Remarks/Arguments:

Applic. No. 10/642,544  
Amdt. dated October 17, 2005  
Reply to Office action of May 17, 2005

**Fig. 2**

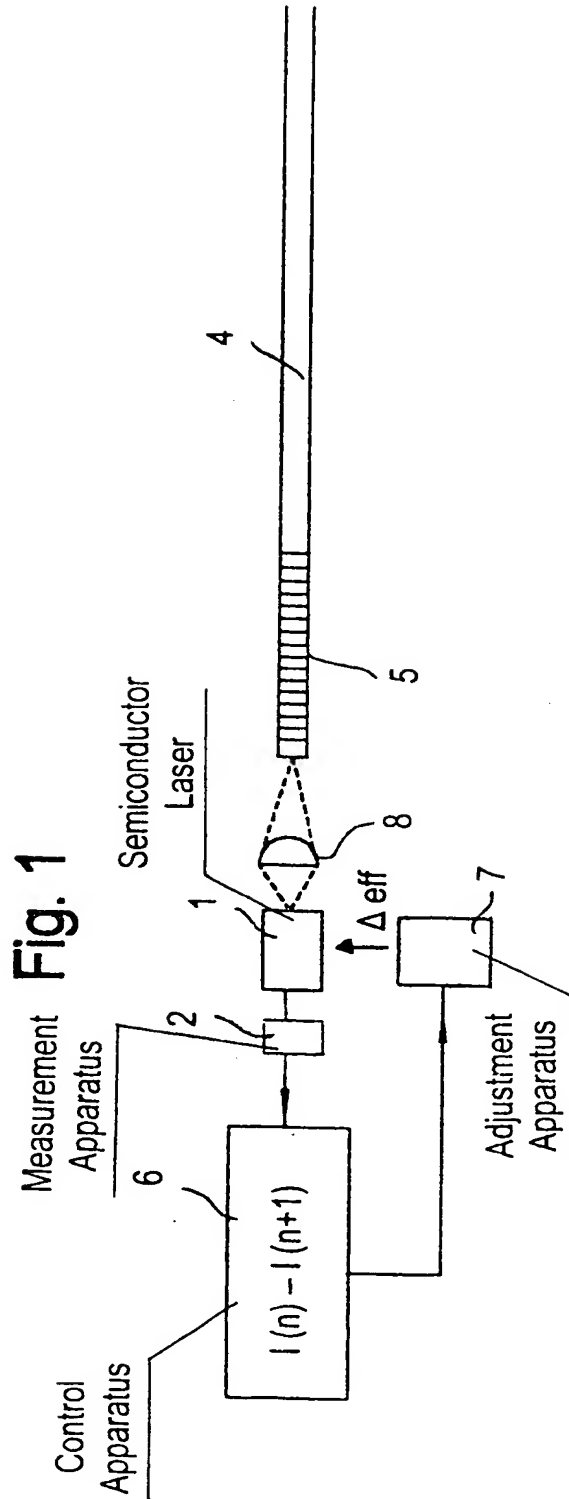
In the second paragraph on page 2 of the above-identified Office action, the drawings have been objected to because it is believed that the caption of reference numeral "21" should be "highly reflective layer" and not "highly reflective laser". As noted above in the Drawing Amendments section, Fig. 2 has been changed to read "highly reflective layer". Therefore, the objection to the drawings by the Examiner is believed to have been overcome.

The attached sheet of drawings includes changes to Fig. 2. This sheet which includes Figs. 1 and 2, replaces the original sheet including Figs. 1 and 2. In Fig. 2, the descriptor for reference symbol "21" was changed to "highly reflective layer".

Please approve the drawing changes that are marked in red on the accompanying "Annotated Sheet Showing Changes" of Figs. 1 and 2. A formal "Replacement Sheet" of amended Fig. 2 is also enclosed.
